INVITATION TO TENDER "ITT" PS20171974
RE-ROOFING SERVICES FOR STANLEY PARK PAVILION

QUESTIONS AND ANSWERS NO. 1

ISSUED ON November 9, 2017

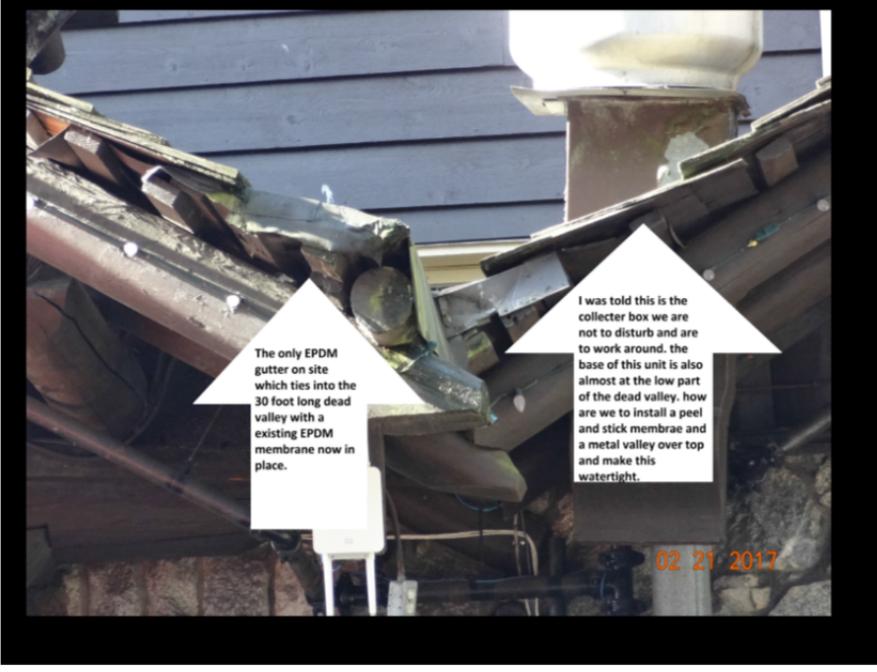
A12	<p>See A3</p>
Q13	<p>Attached are photos of the Collectors Box we are to work around. Please confirm we are not to disturb this box.</p>

<p>The only EPDM gutter on site which ties into the 30 foot long dead valley with a existing EPDM membrane now in place.</p> <p>I was told this is the collector box we are not to disturb and are to work around. the base of this unit is also almost at the low part of the dead valley. how are we to install a peel and stick membrae and a metal valley over top and make this watertight.</p> <p>02 21 2017</p>
A13	<p>Yes, Existing collector box on the east elevation to stay in place. Work to be performed around it with proper waterproofing detailing. Assume playing around with existing collector box i.e lifting as required to waterproof the respective area.</p>
Q14	<p>Please confirm that any 2x4 strapping missing, damaged or required to support long sides of plywood will be an extra.</p>
A14	<p>Yes, per summary of work, If existing nailers strip is damaged or deteriorated then replace it with new nailers strip. Size of new nailers strip to match existing nailers strip. This work to be carried out under Time & Material</p>
